**ADMINISTRATIVE AMENDMENT:**

PROJECT NUMBER: 1004606  
APPLICATION NUMBER: 14DRB-70202

**DURANGO**  
Site Plan for Subdivision

Site Plan for Subdivision

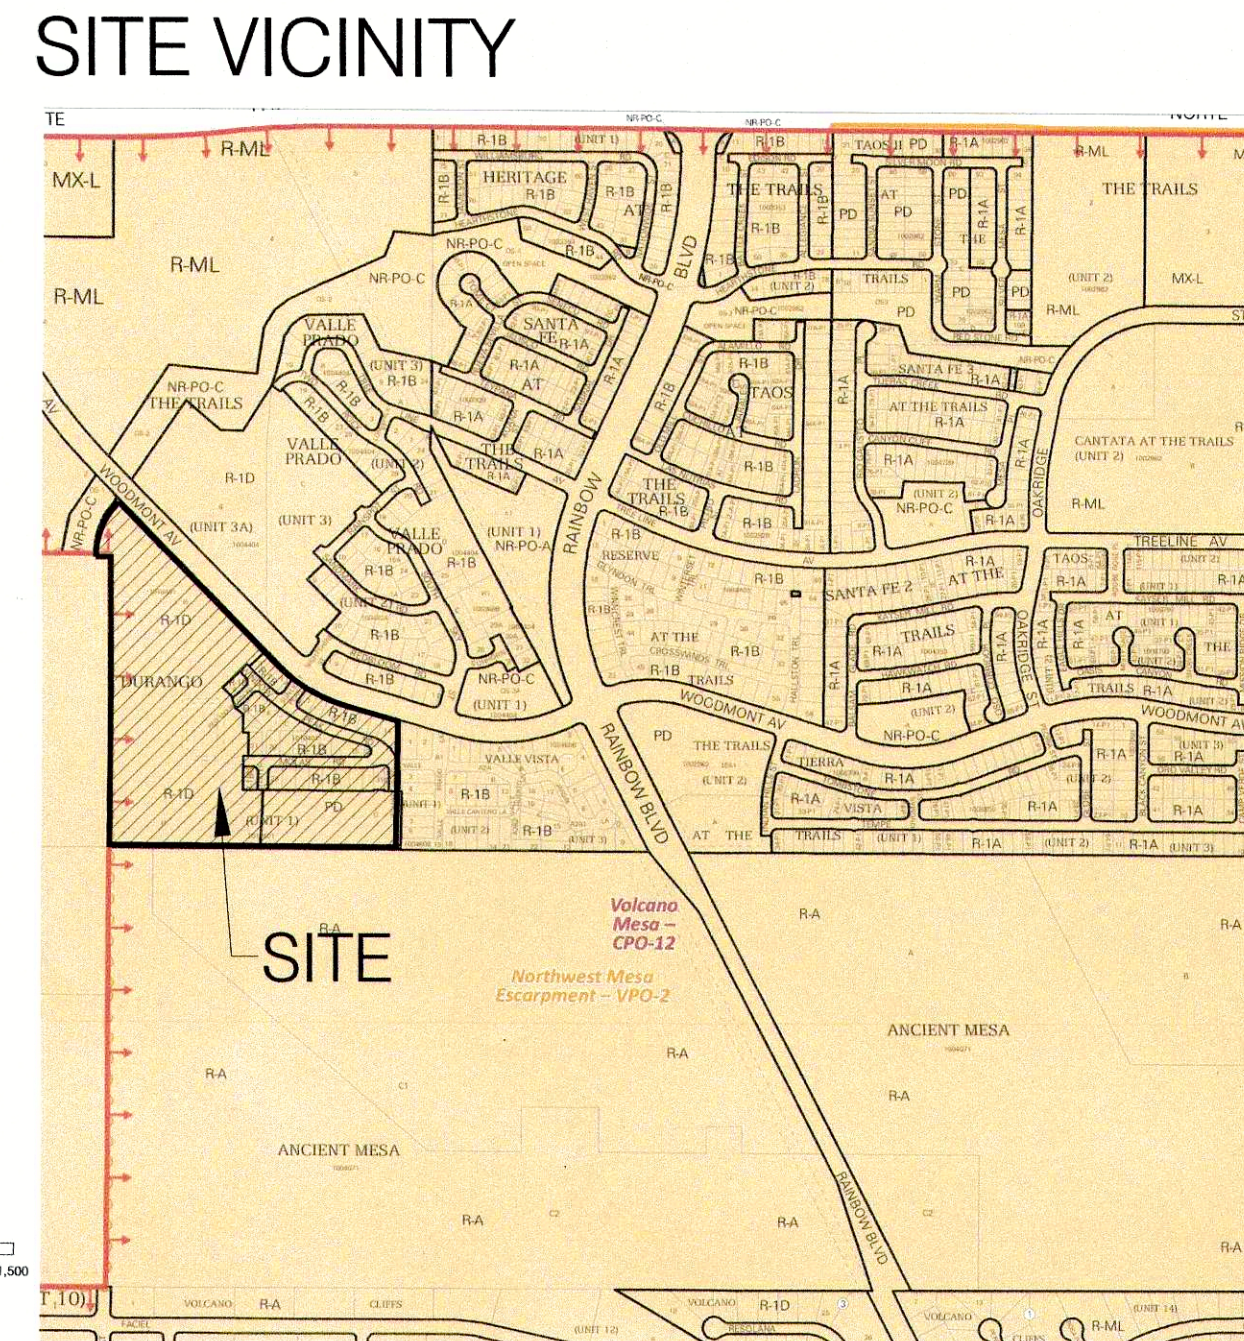
- UPDATED TO THE IDO ZONING (R-1D AND R-1B).
- UPDATED SITE PLAN FOR UNIT 5: 1) ELIMINATED THE 8' PEDESTRIAN PATH, PEDESTRIAN GATE, AND VEHICLE GATE ON THE WEST SIDE OF MANCOS STREET, 2) ELIMINATED EXTENSION OF WINDOW PEAK ROAD WEST OF MANCOS STREET, 3) REDUCED MANCOS STREET ROW FROM 47' TO 42', 4) CREATED BUFFER BETWEEN MONUMENT AND LOT 18 AT SW CORNER (THERE WAS NO BUFFER ON THE PREVIOUSLY APPROVED PLAN), AND 5) RECONFIGURED HOA TRACTS AS A RESULT OF SITE PLAN CHANGES NOTED ABOVE.
- ADJUSTED BOUNDARY BETWEEN UNITS 2 AND 3, REMOVING 2 LOTS (FORMER LOTS 10 AND 11, DURANGO UNIT 2) FROM UNIT 2 AND PUTTING THEM INTO UNIT 3 (DID NOT CHANGE TOTAL LOT COUNT).
- REMOVED VIEW FENCE DETAIL.
- ADDED TYPICAL MONUMENT SIGN ELEVATION.
- CONFIRM SETBACKS FOR ALL UNITS AS FOLLOWS:
  - FRONT: 15 FEET
  - REAR: 15 FEET
  - SIDE: 5 FEET (CORNER LOT: 10 FEET)
